**ADDENDUM NO. 2
TO THE CONTRACT DOCUMENTS
for the construction of the
Ozone Biofiltration System
(UOSA Contract OBF)
Upper Occoquan Service Authority**

ADDENDUM NO. 2
to the
CONTRACT DOCUMENTS
for the construction of
Ozone Biofiltration System
UOSA Contract OBF
Upper Occoquan Service Authority
Centreville, VA

Date: January 18, 2024

DESIGNED BY: C. STILLWELL
DRAWN BY: M. RUSH
SHEET CHK'D BY: C. STILLWELL
CROSS CHK'D BY: B. ZUIDERVIJLT
APPROVED BY: B. FLINT
DATE: NOVEMBER 2022

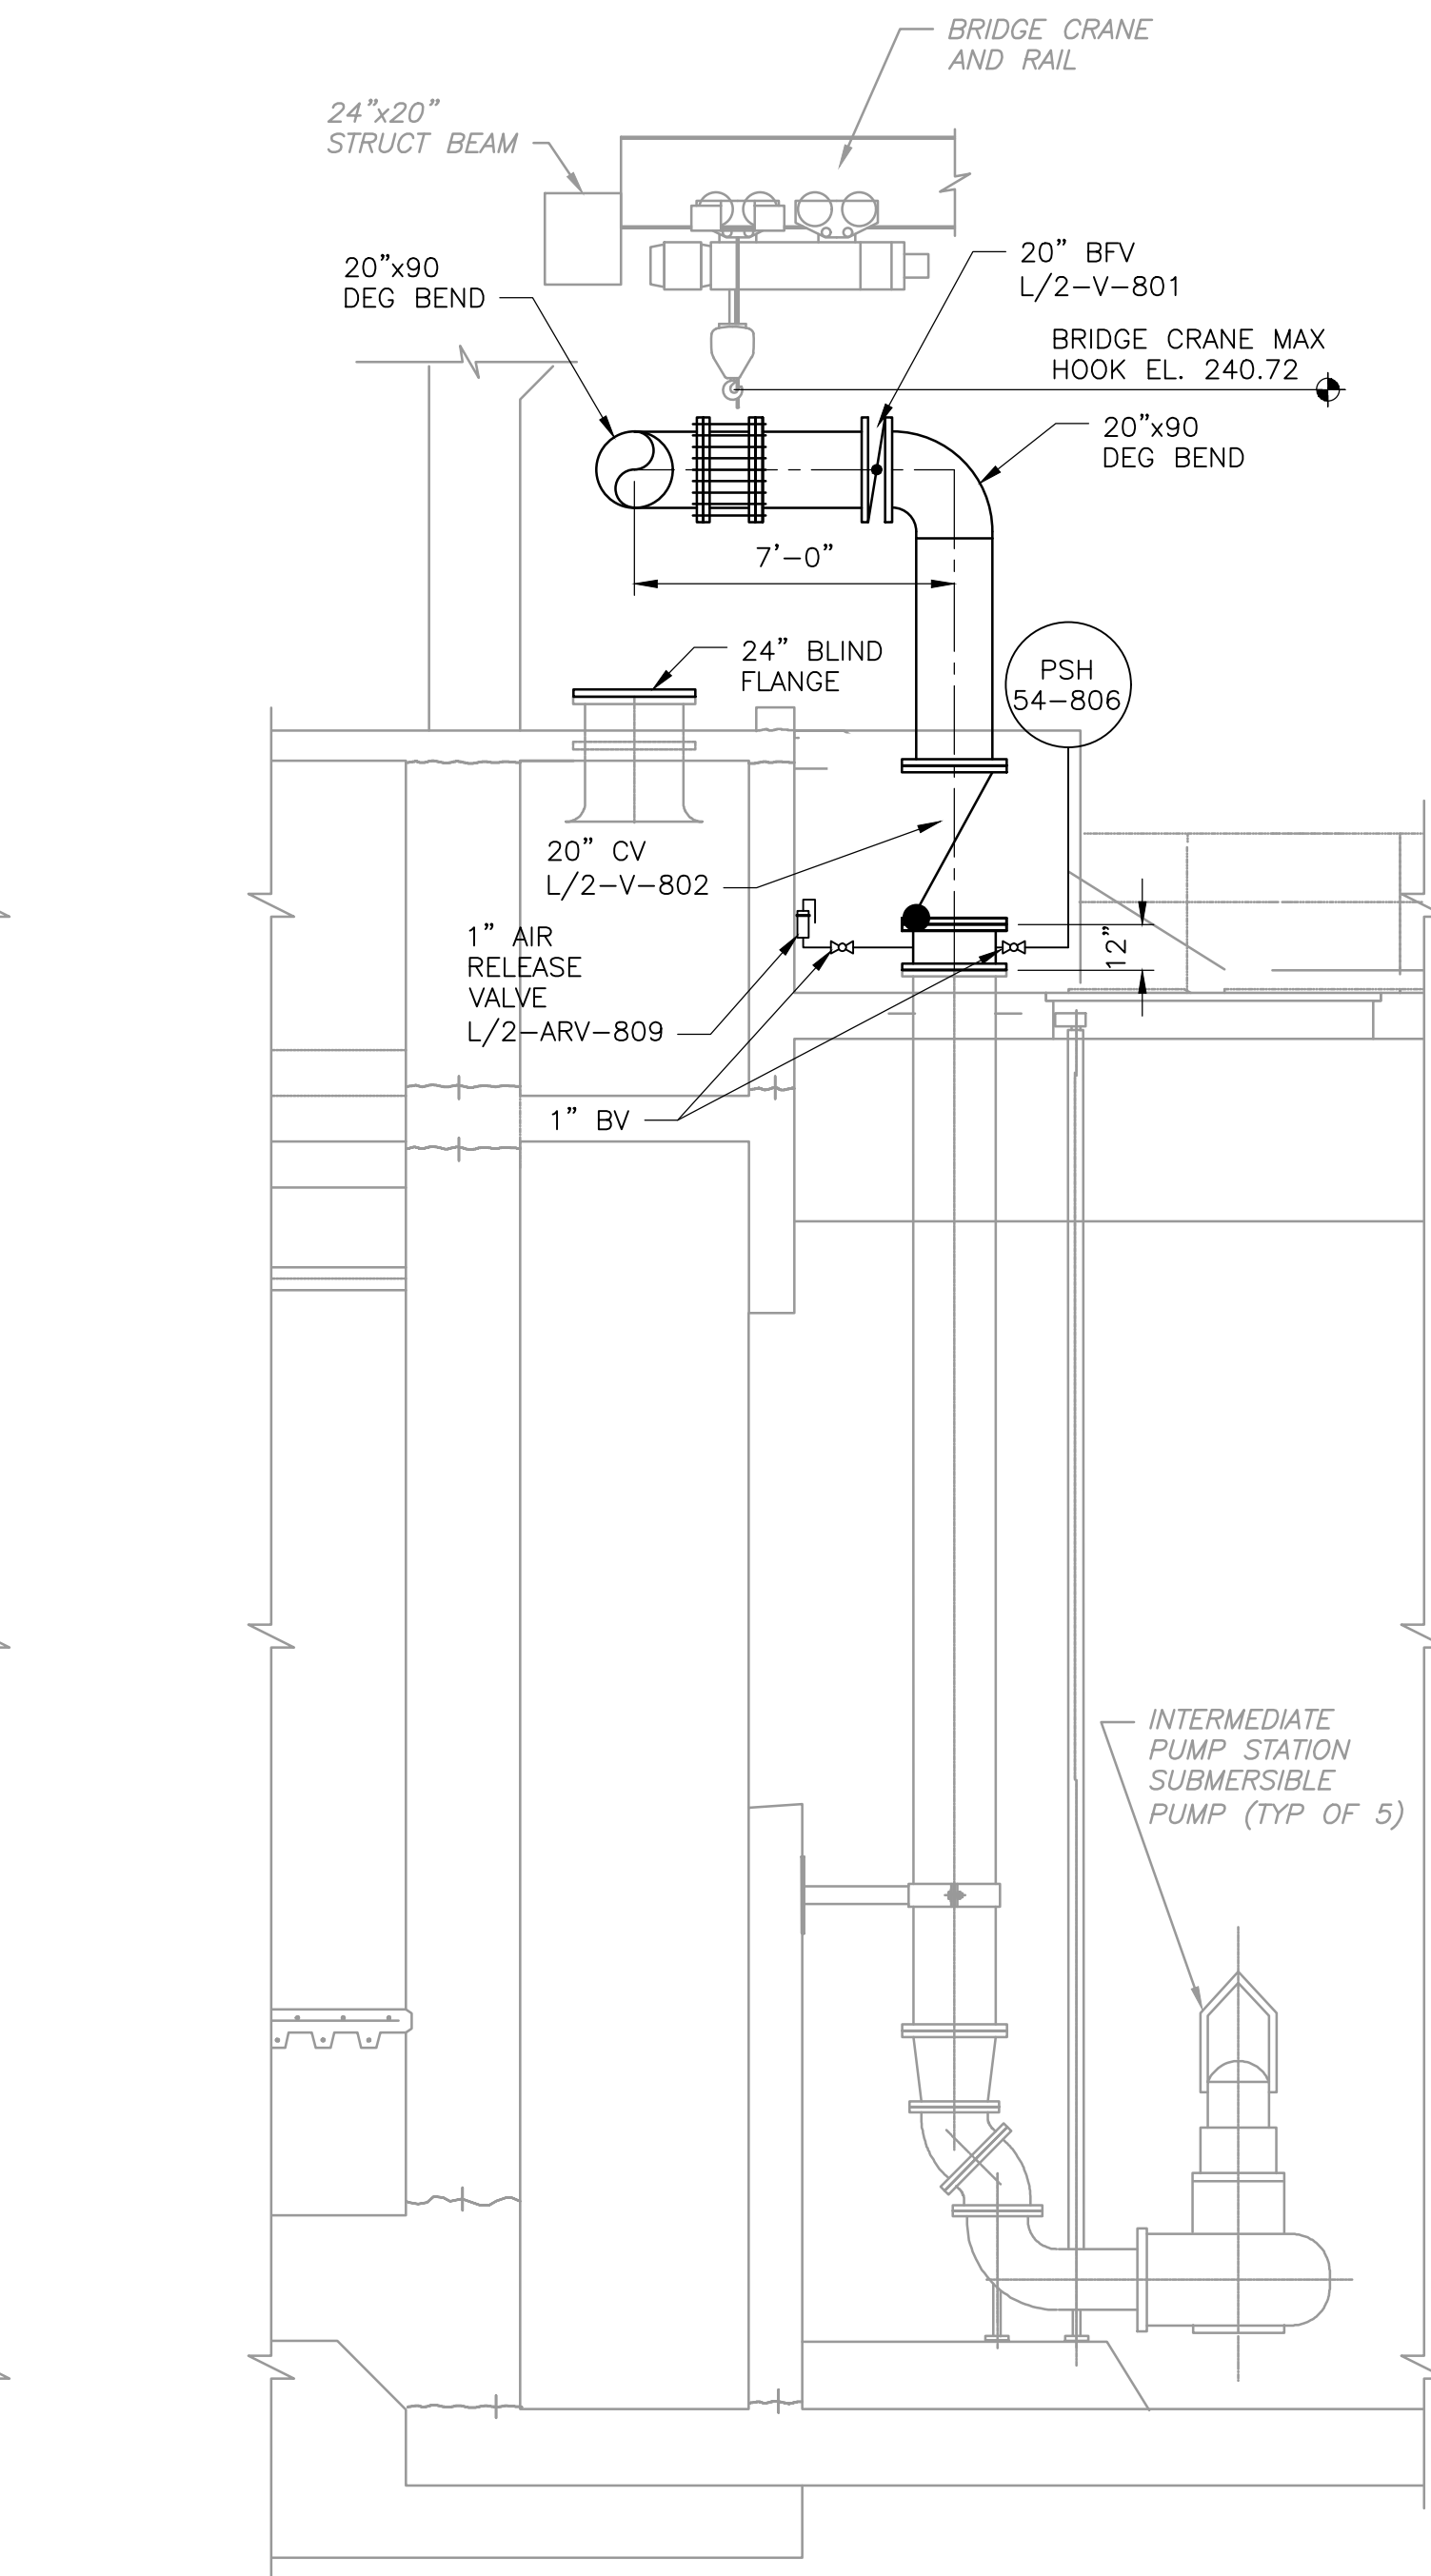
REV. NO.	DATE	DRWN	CHKD	REMARKS
1	12/23	MAR	BWZ	ADDENDUM 2. REVISED ARV SIZE
